Access Compliance Report

Public Rights-of-Way

Intersection ID: 14079	Main Street: S_KINGS_DR	Cross Street: LUTHER_ST	Location: E
ADA ID: 81B47DD21A2E	Ramp Type: ParaDiag	Initial Pass/Fail: Fail	Overall Compliance: No
			Severity Score: 26.25

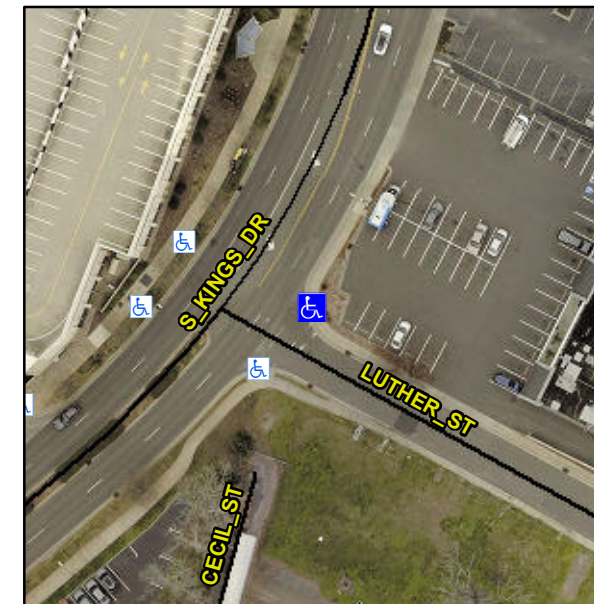
LT RP < 5%

R304.5.3, R304.3.2

Remove & Replace Curb Ramp With Two New Directional Ramps or Equivalent.
